# AXC F 2152 – CHANGE NOTES

## Change notes for the AXC F 2152 controller

108427\_en\_21

Current firmware version: 2021.0 LTS

Figure 2 Select Trigger task

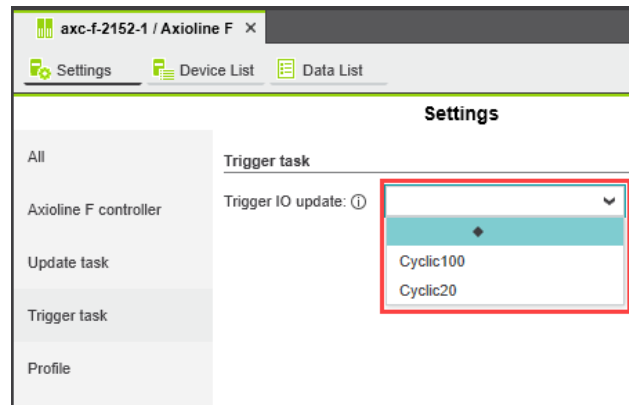
- Select the “Trigger task” view in the “Settings” editor.
- In the drop-down list, select the task that is to trigger the Axioline F I/O data update.

If you do not select a task, the update will occur by default every 50 ms.
